WATERVUE

643-651 HUNTER STREET NEWCASTLE NSW 2300

DEVELOPMENT APPLICATION SHEET LIST		
DRAWING NO.	TITLE	REVISION
DA000	PLAN - LOCATION & DRAWING SCHEDULE	F
DA002	SITE ANALYSIS	B
DA003	PREDICT LOCATION PLAN	C
DA005	SITE PLAN	B
DA006	SHADOW DIAGRAMS	B
DA007	SHADOW DIAGRAMS	B
DA008	SHADOW DIAGRAMS	A
DA009	SOLAR ACCESS DIAGRAM	B
DA010	VENTILATION DIAGRAMS	B
DA011	PLANNING - GFA	C
DA012	UNIT AREA FOR CARPARKING GEN.	B
DA101	GROUND FLOOR	E
DA102	PARKING LEVEL 1	D
DA103	PARKING LEVEL 2	C
DA104	PARKING LEVEL 3	C
DA105	PLAN - PODIUM	E
DA106	PLAN - TYPICAL LOWER	D
DA107	PLAN - TYPICAL UPPER	C
DA111	PLAN - PENTHOUSES	B
DA112	ROOF	B
DA200	STREETSCAPE ELEVATIONS	B
DA201	ELEVATIONS - NORTH AND EAST	F
DA202	ELEVATIONS - SOUTH AND WEST	C
DA301	SECTIONS	C
DA321	RAMP SECTION CARPARK	C
DA401	PERSPECTIVE	B
DA402	PERSPECTIVE	B
DA403	PERSPECTIVE	B
DA409	MATERIALS + FINISHES	B
DA801	PODIUM LEVEL PRIVACY SCREENS	A
DA802	SIGNAGE DESIGN INTENT	A

DRAWING No. **DA202**
DRAWING TITLE **ELEVATIONS - SOUTH AND WEST**
SCALE **1 : 200 @ A1**
DATE **2022**

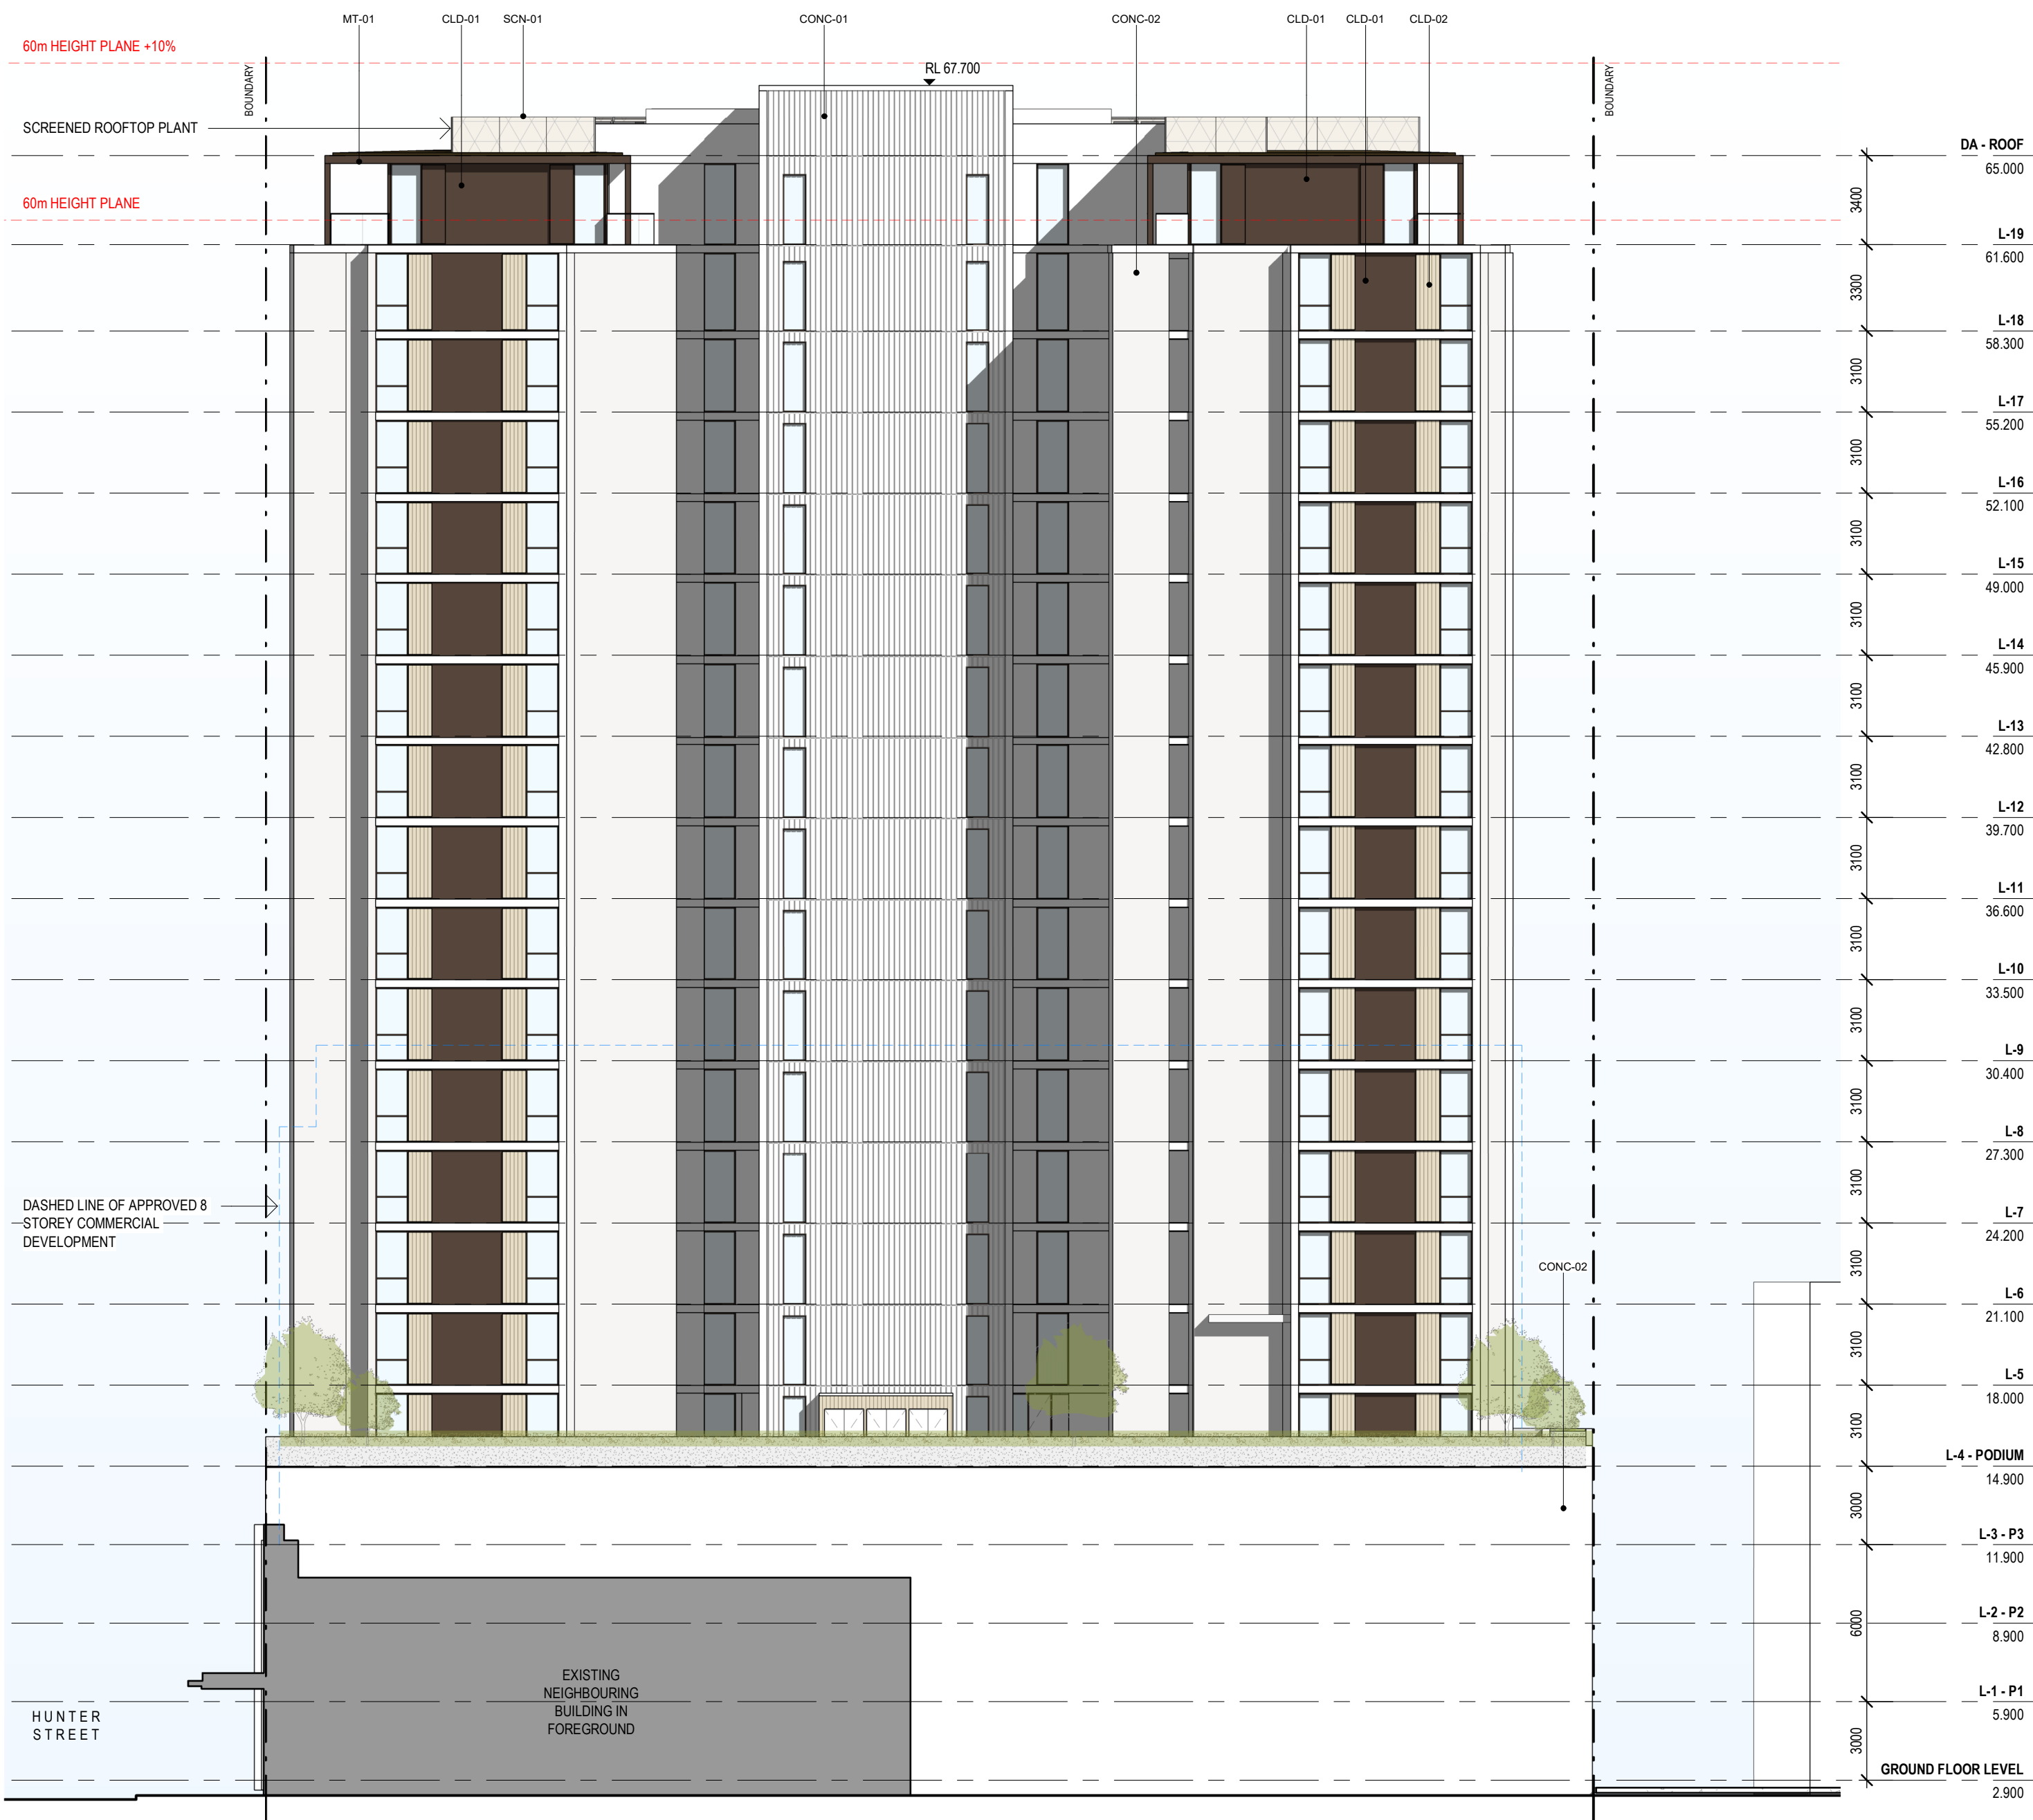
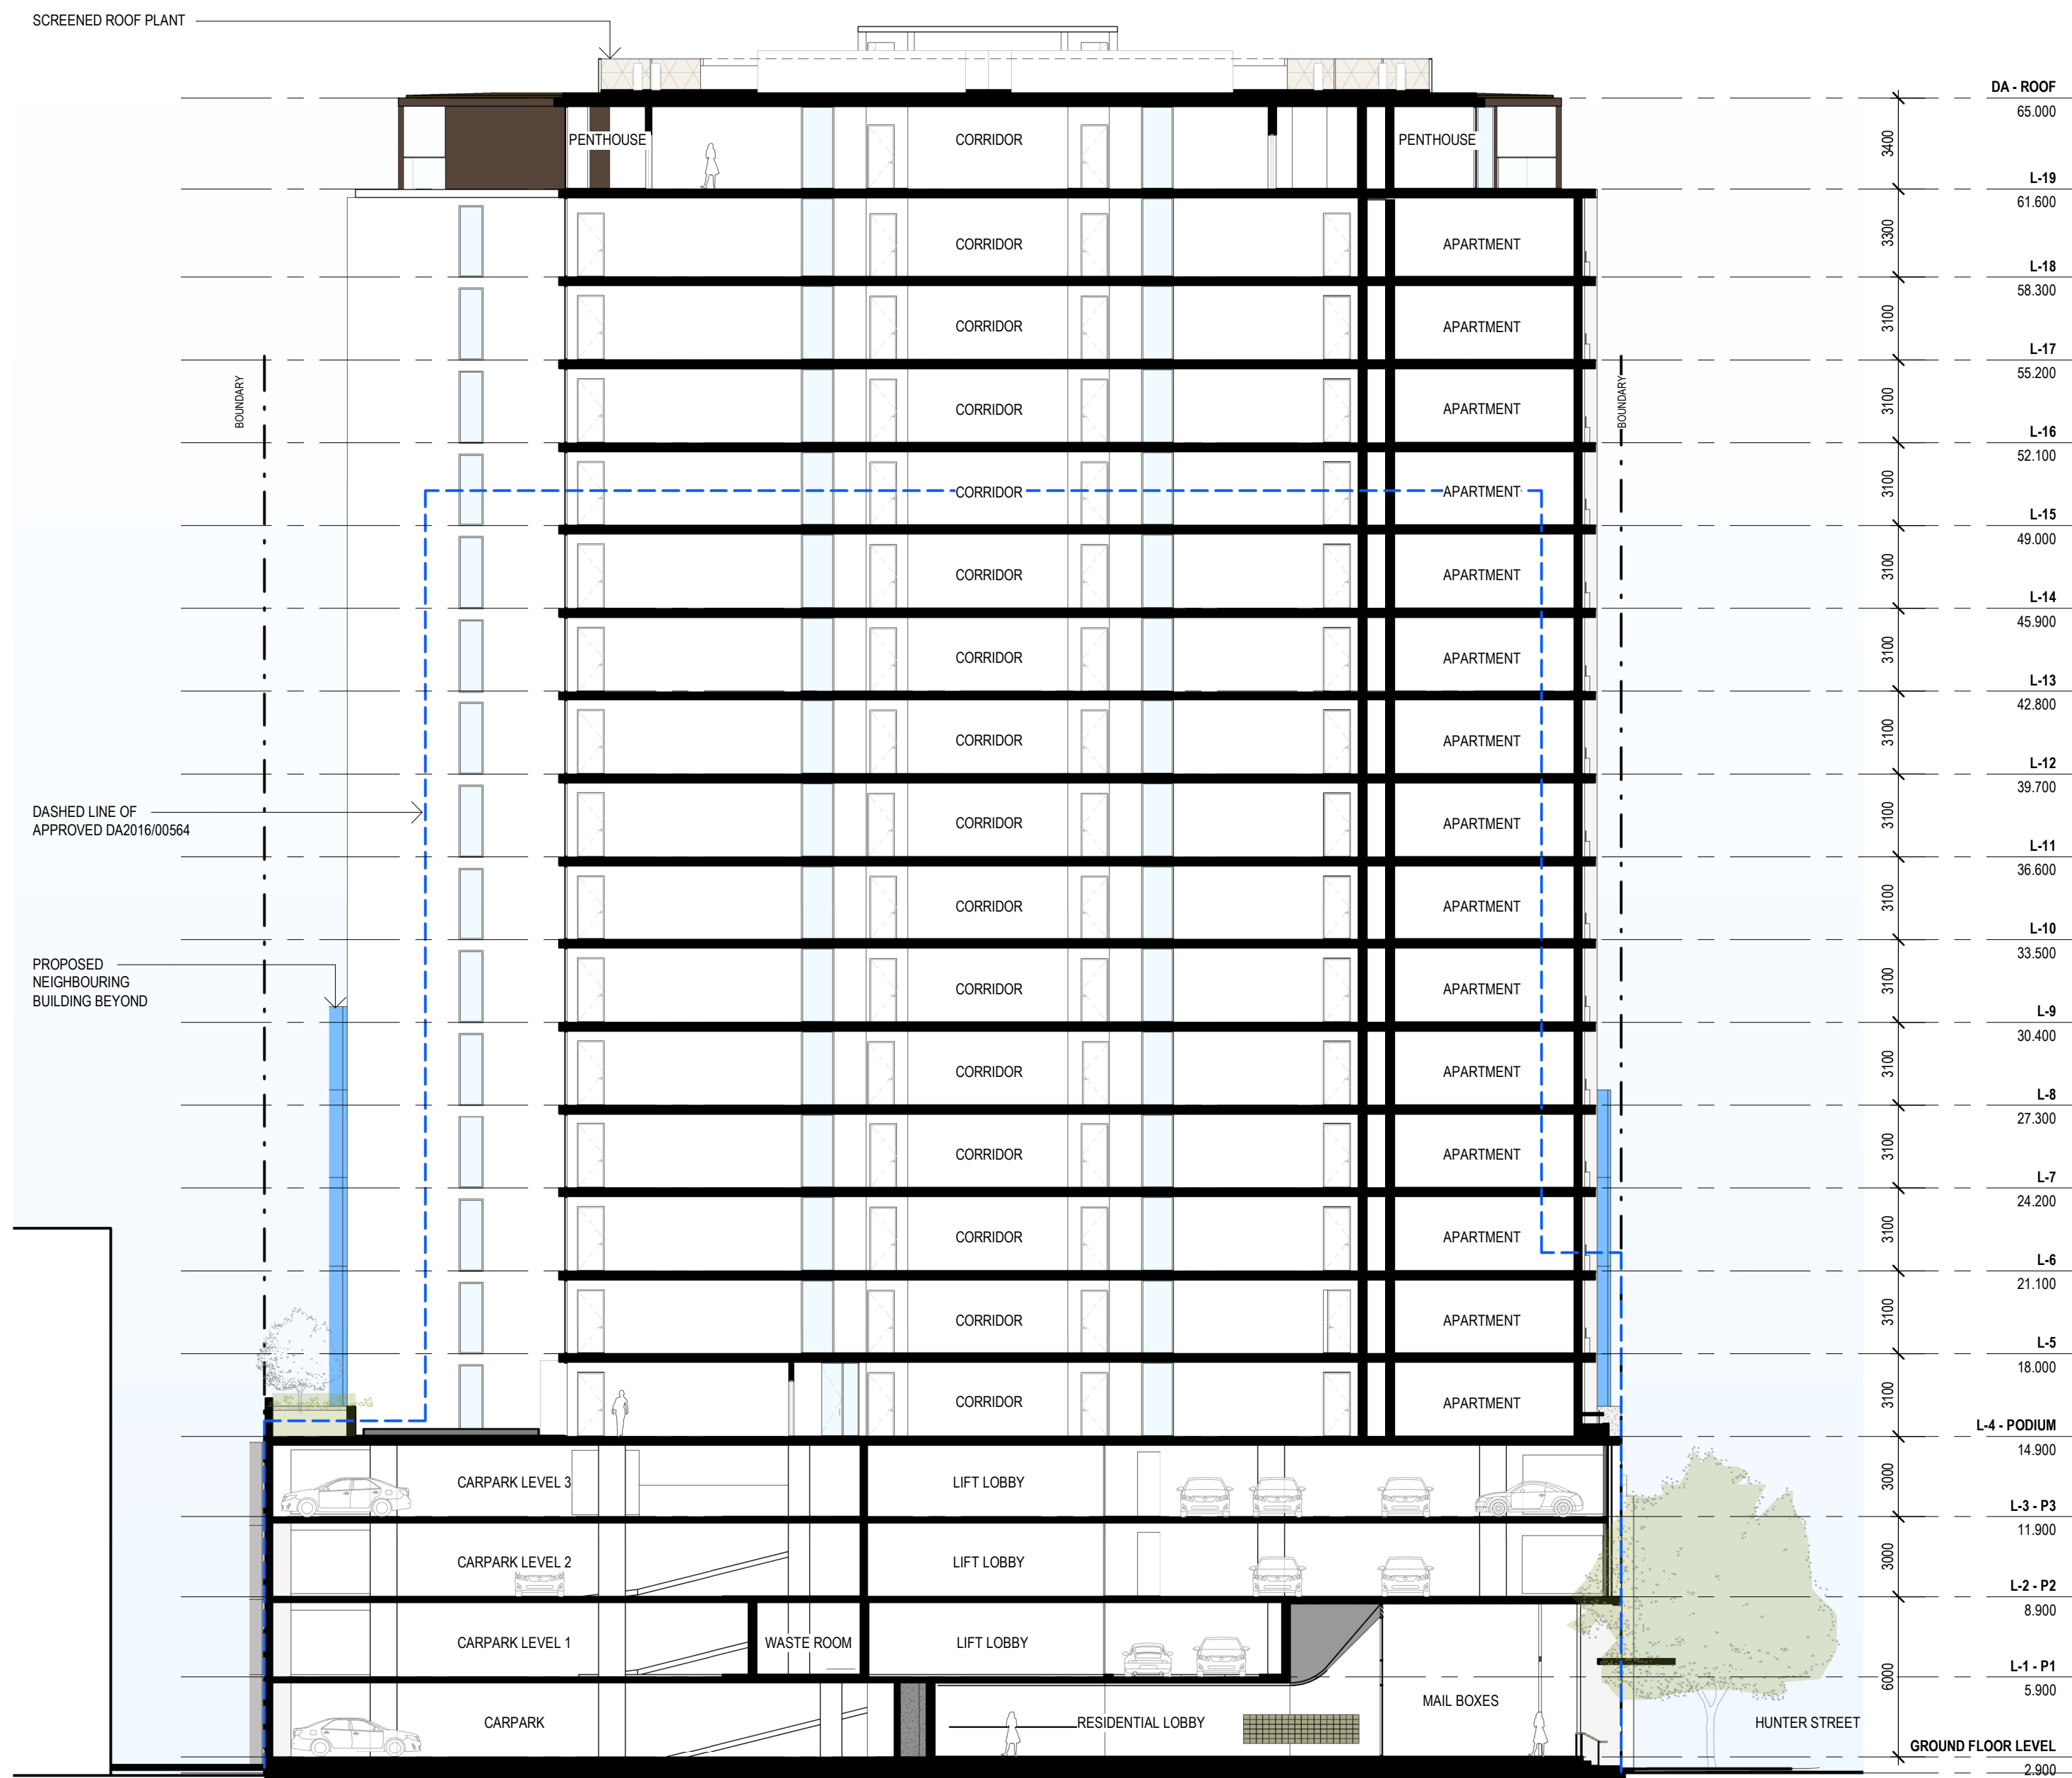
- GROUND FLOOR CARPARKING LEVEL LOWERED BY 300MM
- DRIVEWAY GRADES UPDATED TO SUIT UPDATED PARKING LEVEL
- DOOR TO FIRE EGRESS CORRIDOR RELOCATED
- STEP ADDED TO FIRE EGRESS PATH TO SUIT UPDATED PARKING LEVEL
- STEPS AND PLATFORM ADDED TO MSB ROOM TO SUIT UPDATED PARKING LEVEL
- MAIL ROOM ADDED TO RESIDENTIAL LOBBY
- MAILBOXES RELOCATED INTO THE RESIDENTIAL LOBBY
- MOTORCYCLE SPACE DISTRIBUTION ACROSS L1, L2 AND L3 UPDATED (TOTAL REMAINS THE SAME)
- SECURE ENTRY ADDED AT BASE OF RESIDENTIAL CARPARK RAMP OF TO L1 RAMP LENGTH UPDATED TO SUIT UPDATED GROUND FLOOR PARKING LEVEL
- GARAGE ADDED TO L1 AND L2
- STORAGE CAGE ARRANGEMENT UPDATED
- LANDSCAPE COURTYARD ACCESS DOOR ADDED TO PODIUM LEVEL
- POOL PERGOLA SHOWN IN ELEVATION
